DETAILED ACTION

Response to Amendment

1. The applicant's amendment filed 3/9/2011 has been fully considered and made of record.

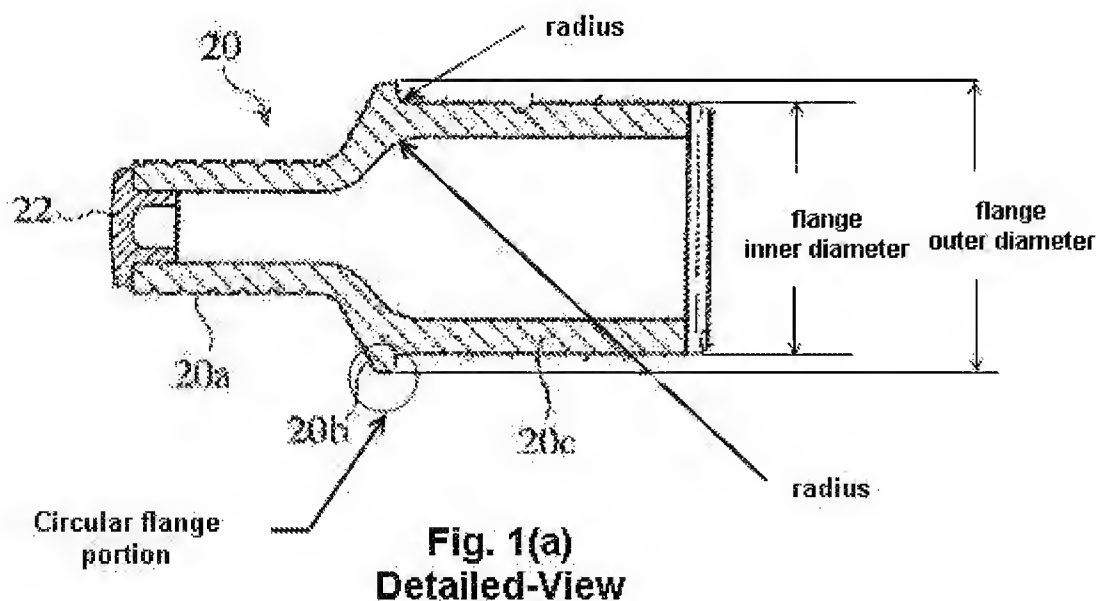
Claim 1, lines 8-9, the limitation of “a flange which is sandwiched by said small-diameter portion and said large-diameter portion” is confusing and unclear how this flange can be sandwiched by the small and large diameter portions of the shaft portion? Applicant's Figures 1(a)-(b) show that the flange is in between a large and small diameter portions. Therefore, it is not clear what the Applicant is trying to claim by using

the word “sandwich.” For the examination purposes, the Examiner considers that any flange feature located in between a small-diameter and a large-diameter portions would read on this claimed limitation.

Claim 1, lines 9-10, the limitation of “an inner diameter and an outer diameter of said flange slowly expand together” is confusing and unclear as to what exactly is considered an inner and an outer diameter and how would they expand slowly. Note that Fig. 1(a) of Applicant clearly labels only the circular lip on the shaft portion 20 as flange 20b. As such, the only diameters of the flange portions are shown on the “Detailed View” below. In addition, there are some internal and external radii (as labeled below) but it is not clear how these can be considered as inner and outer diameters of the flange portion since they don’t seem to be part of the flange.

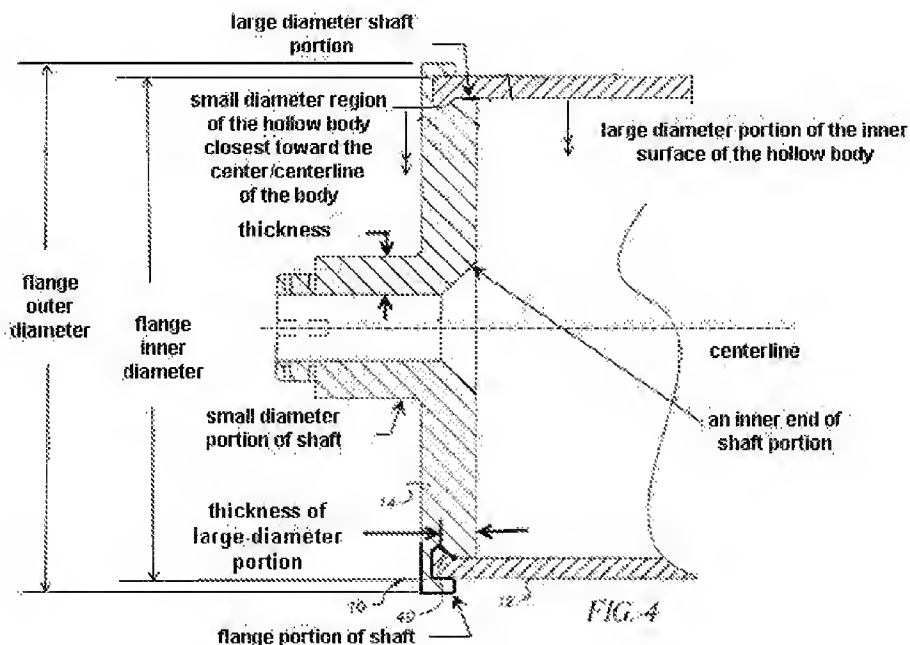
As applied to claim 1, Kass et al. '048 teach a roller with hollow body with shaft portions connected to the said body capable of operating at elevated temperature (col. 1, lines 7-10, Fig. 4). Kass et al. '048 further teach (Fig. 4 below) that an inner surface of said body comprises large-diameter regions on both sides (ends) and a small-diameter region in the center (between the two ends), and each of said shaft portions is an integral hollow cylinder having a small-diameter portion, a large-diameter portion and a flange which is sandwiched by (located in between) said small-diameter portion and said large-diameter portion, said small-diameter portion and said large-diameter portion of each of said shaft portions have approximately the same thickness (at the particular region labeled in Fig. 4) and the large-diameter region of said body is connected to the large-diameter portion of said shaft portion (as shown in Fig. 4).

diameter region of said body is shrink-fit to the large-diameter portion of each shaft portion (Fig. 4 above, col. 4, lines 7-10).

As applied to claims 9, 10 and 12, Kass et al. '048/Imamura et al./Hamayoshi/Kass et al. '891 teach the invention cited. Kass et al. '048 further teach the roll wherein a ratio of the inner diameter of each small-diameter region of said body to the inner diameter of each large-diameter region of the body is 0.9 or more and less than 1.0 (as in claim 9 shown in Fig. 4 above); that the large-diameter region of said body is longer than the large-diameter portion of said shaft portion, so that there is a gap between the end of each small-diameter region of said body and the inner end of said shaft portion (as in claim 10 shown in Fig. 4 above) and that a ratio of the outer diameter of said body to the outer diameter of the small-diameter portion of each shaft portion is 2-10 (as in claim 12 shown in Fig. 4 above).

As applied to claim 8, Kass et al. '048/Imamura et al./Hamayoshi/Kass et al. '891 teach the invention cited. Kass et al. '048 (Fig. 4 above) further teach a shrink-fit connection between the shaft portion and the hollow body. However, the limitation of "shrink fitting ratio in a range of 0.01/1000 to 0.5/1000" is not given any patentable weight since both claims 7 and 8 are considered product-by-process claims and this product by process limitation is already taught by the structure of Kass et al. '048/Imamura et al./Hamayoshi/Kass et al. '891 and this extra limitation of the shrink fit ratio does not have any effect on the overall structure. Furthermore, it would have been obvious to one of ordinary skill in the art at the time of invention to have selected the

As applied to claim 11, Kass et al. '048/Imamura et al./Hamayoshi/Kass et al. '891 teach the invention cited. Kass et al. '048 (Fig. 4 above) further teach a ratio between the effective length to the outer diameter of the large-diameter portion of each shaft portion but do not explicitly teach the claimed range.
